Staff Report

Re: PLNPCM2020-00641 – 9th East Mixed Use and Multifamily

Design Review

PROPERTY ADDRESSES: 402 South 900 East and 410 South 900 East

MAIN FLOOR

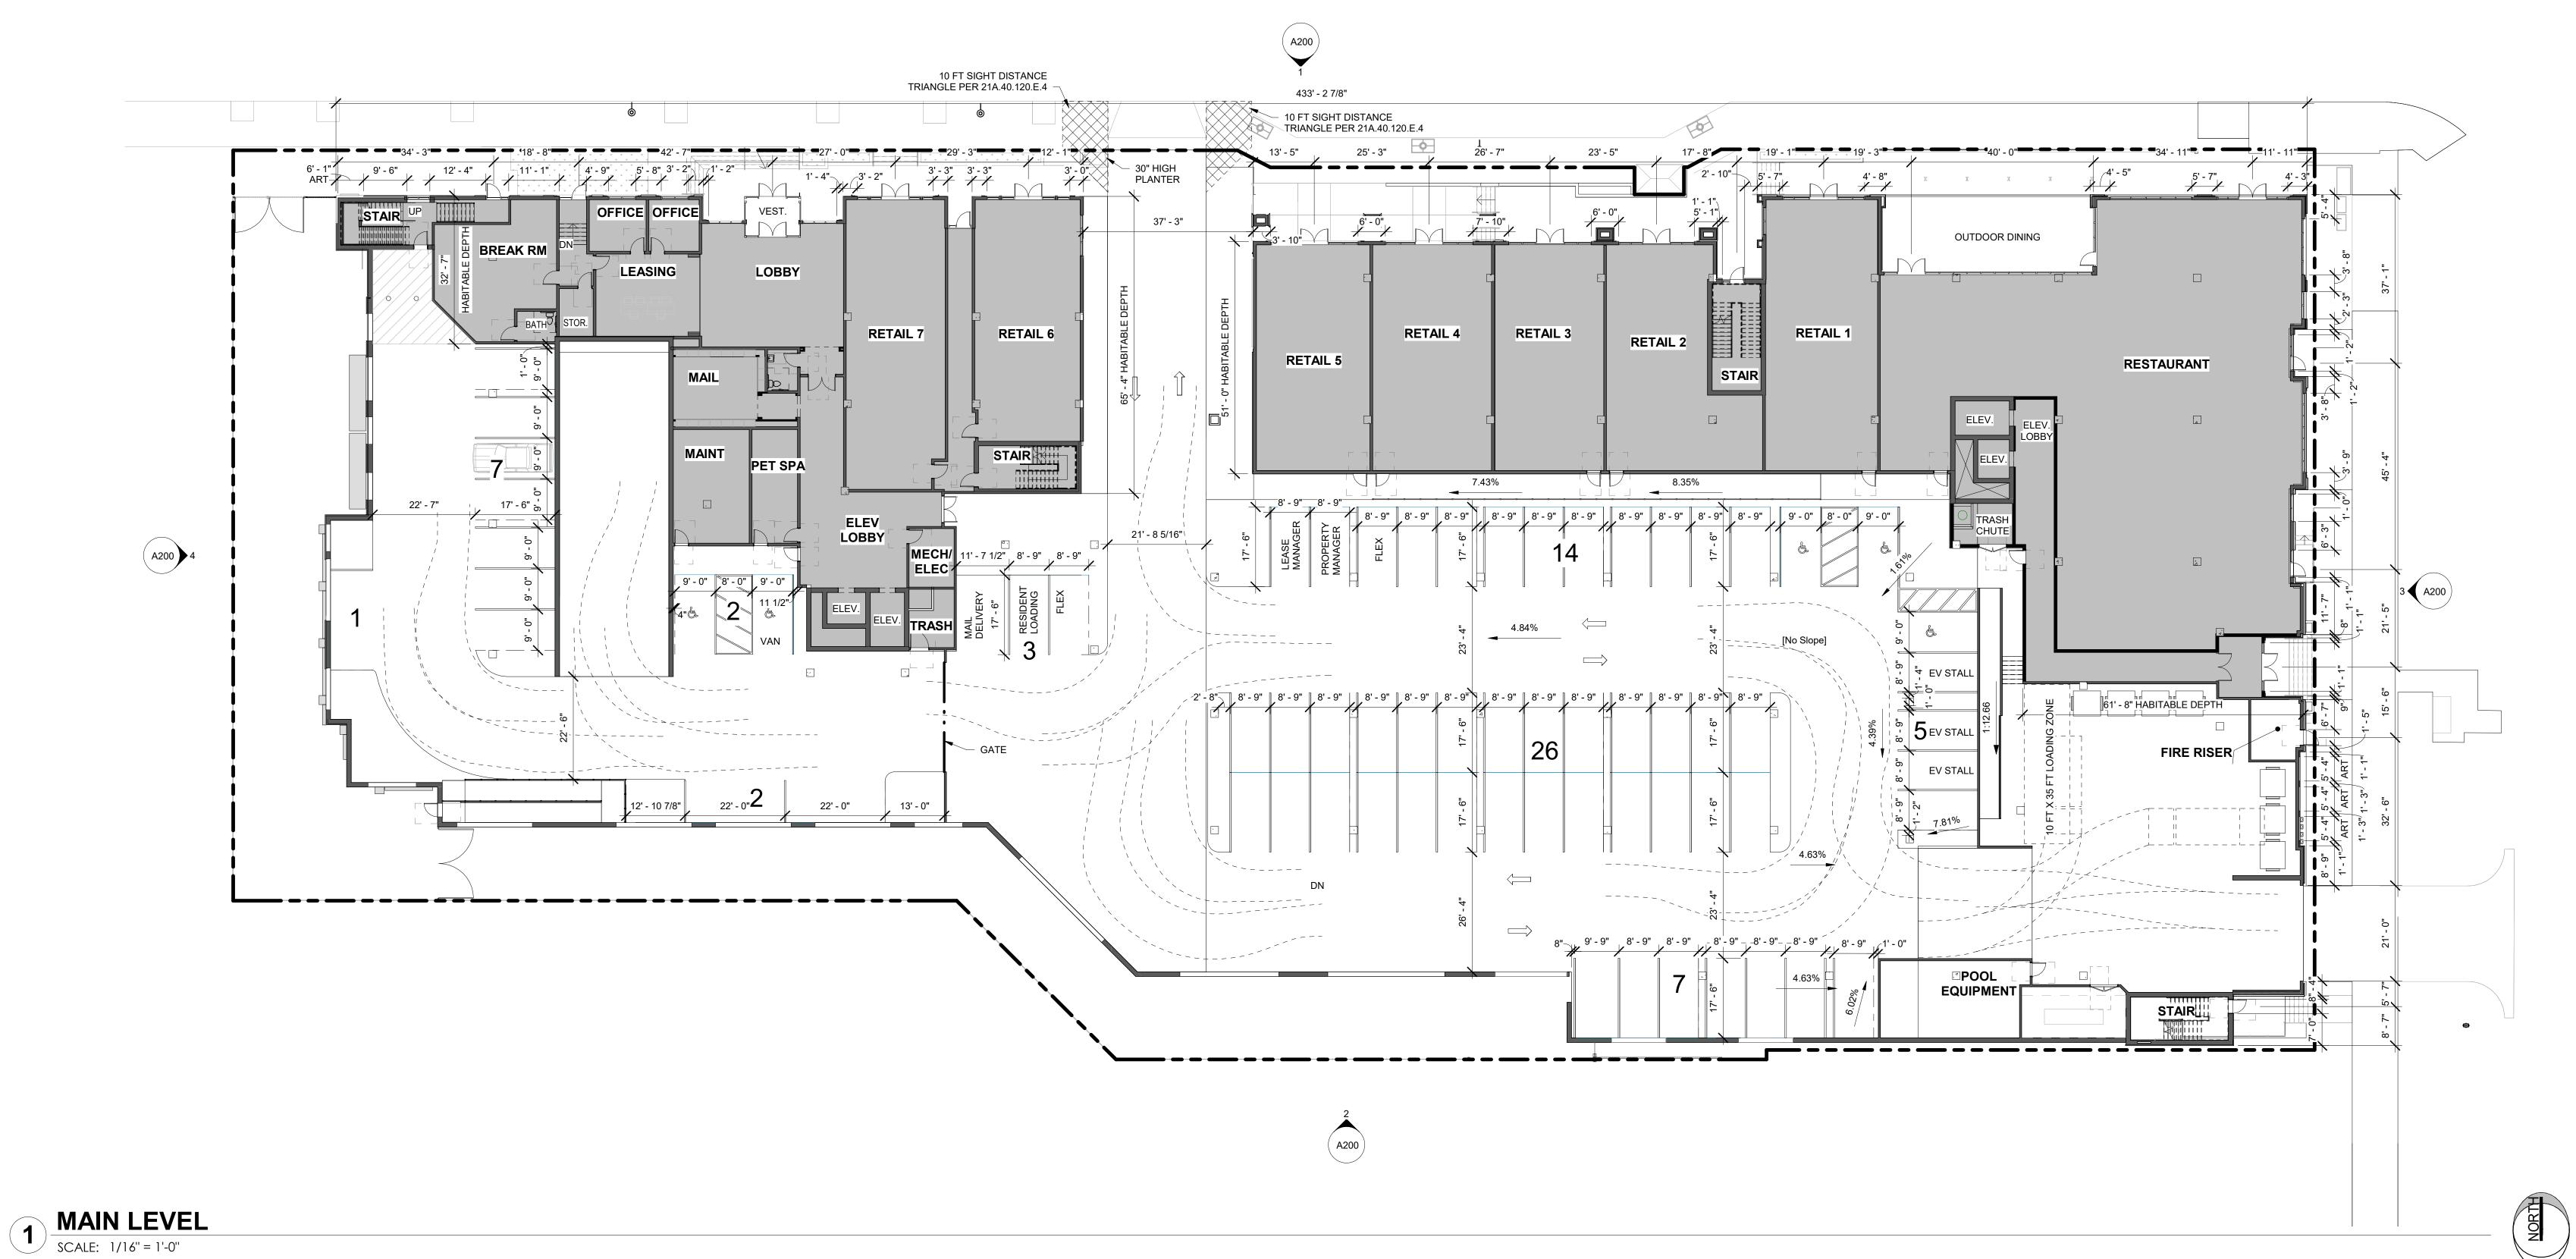
• 21A.37.050.D requires operable building entrances every 40 feet. Please identify the distances between doors and provide plans that can be measured in Adobe Acrobat.

• 21A.37.050.E limits the maximum length of any blank wall to 15 feet. Please identify the distances between windows, doors, etc. and provide plans that can be measured in Adobe Acrobat.

• #27 Identify the depth of the habitable spaces and as requested previously, please provide a plan set that can be measured in Adobe Acrobat.

Response: We have added dimensions between each building entrance to sheet A101 – Main Floor Plan.

Response: We have added dimensions of the wall space between storefront and doors along the north and east facades to sheet A101 – Main Floor Plan.

Response: We have added habitable depth dimensions on our main level floor plan, see sheet A101 Main Floor Plan.

Response: We have added sight distance triangles per 21A.40.120.E.4 on sheet A101 – Main Floor Plan.

A102

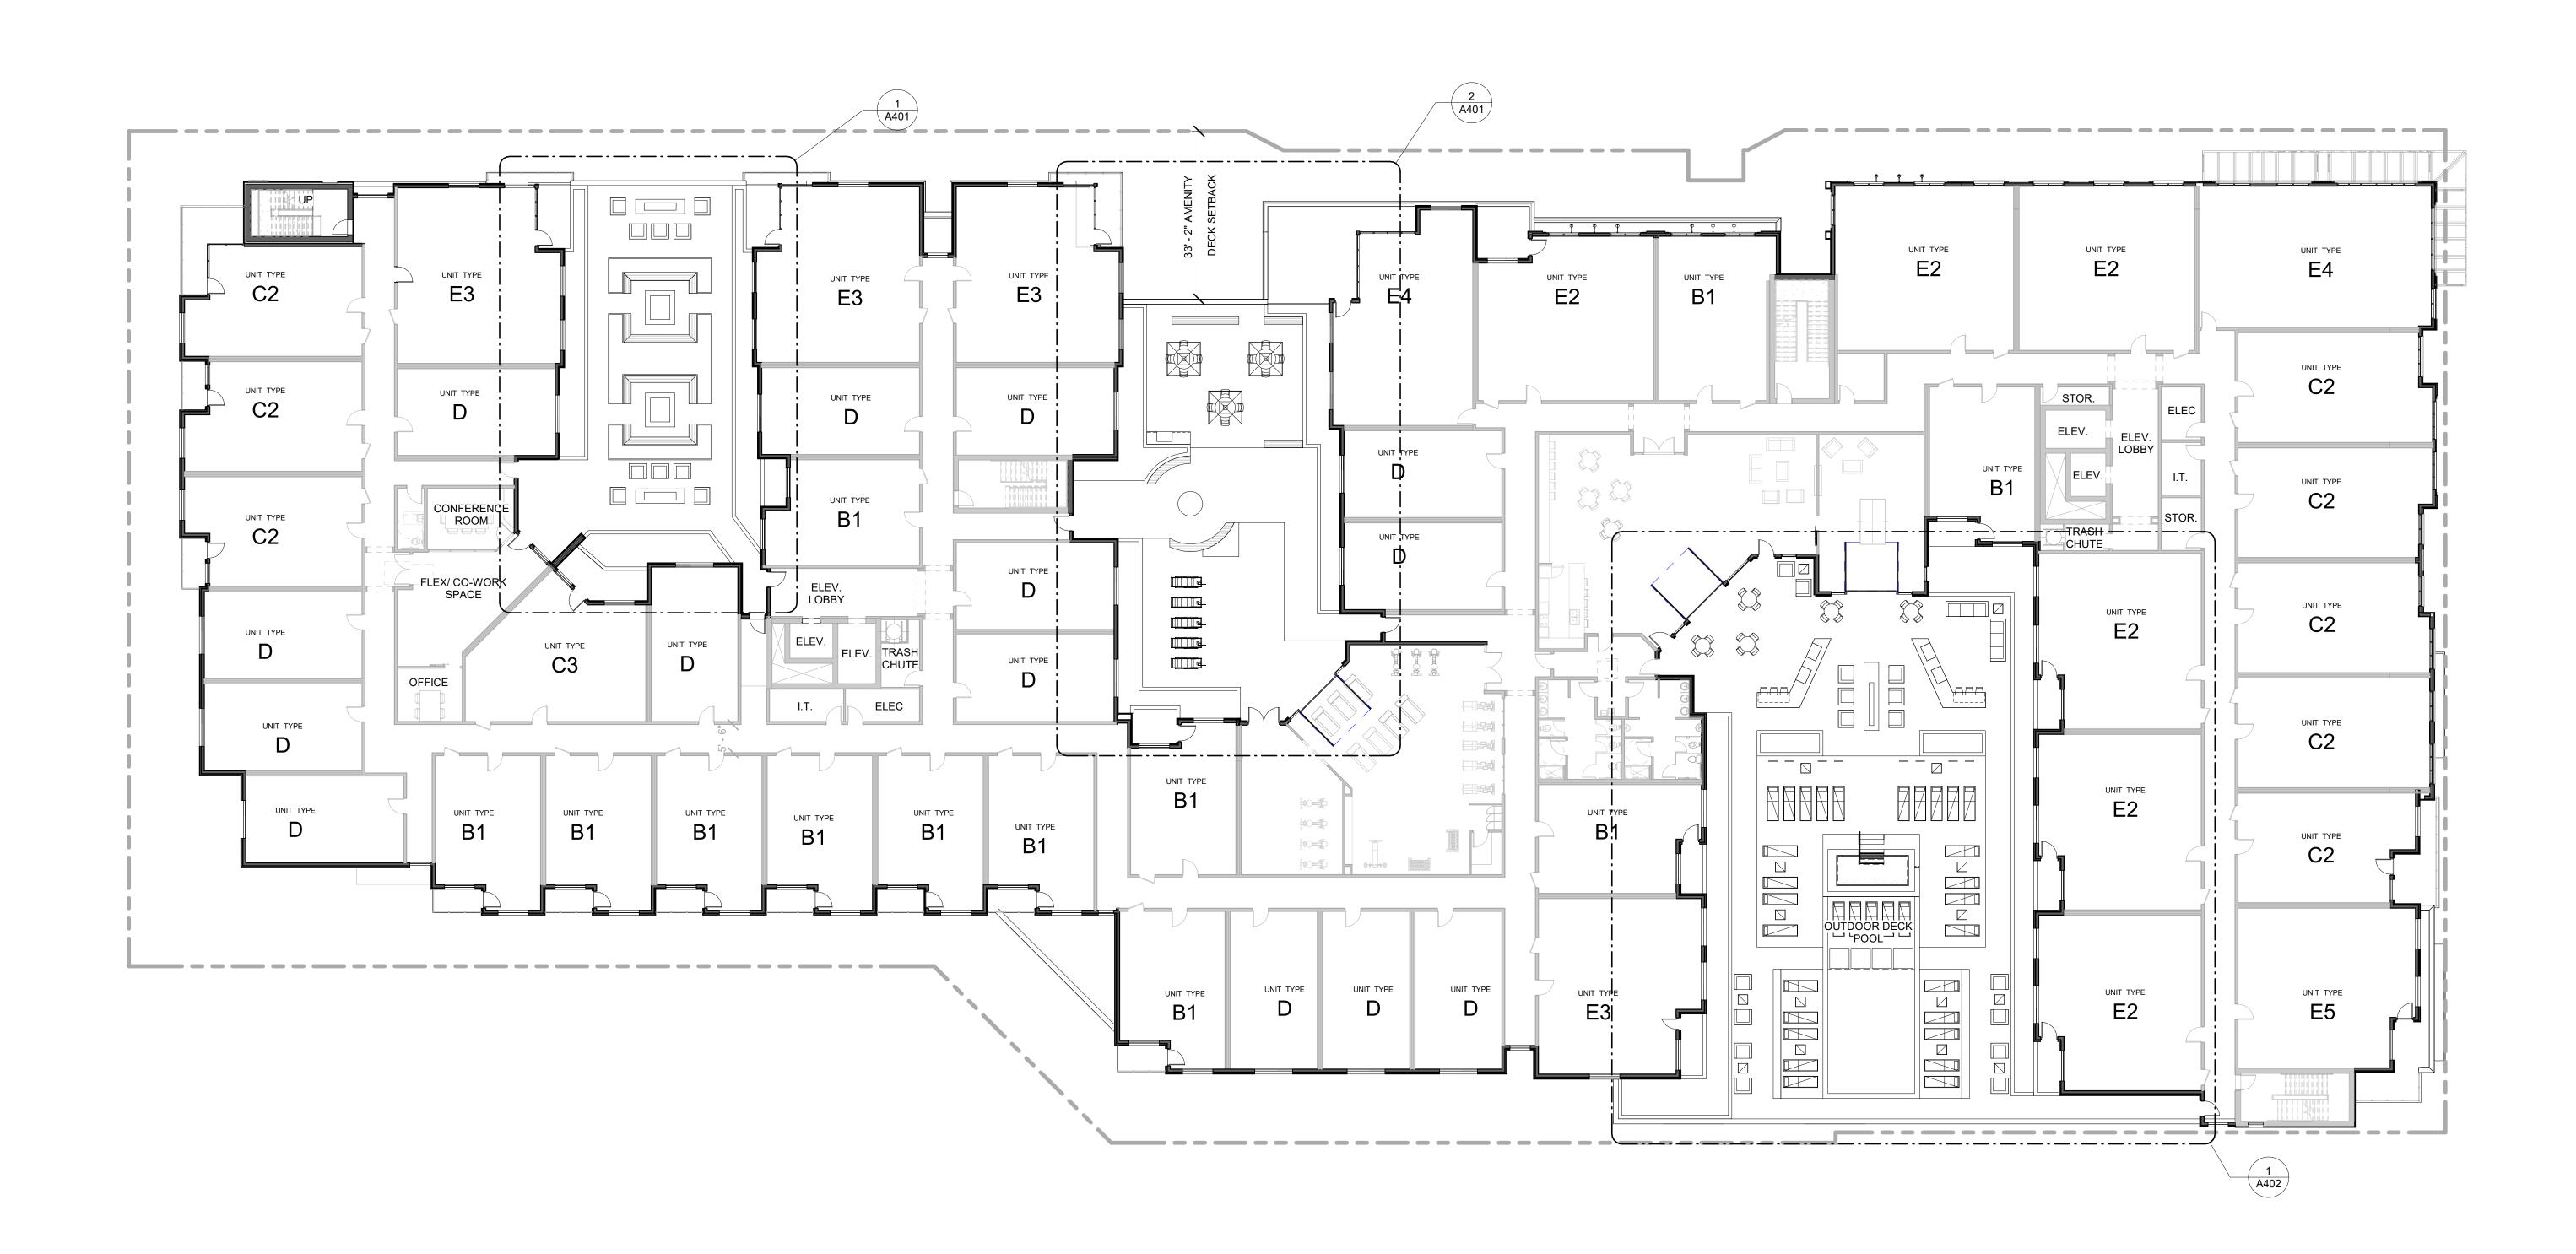
• Generally, consider increasing articulation to provide the appearance of increased separation between sections of the building. (21A.59.050.D.2 and E.1).

Response: We have increased the setback of the second floor amenity deck/parking entrance from the front façade, see sheet A102.
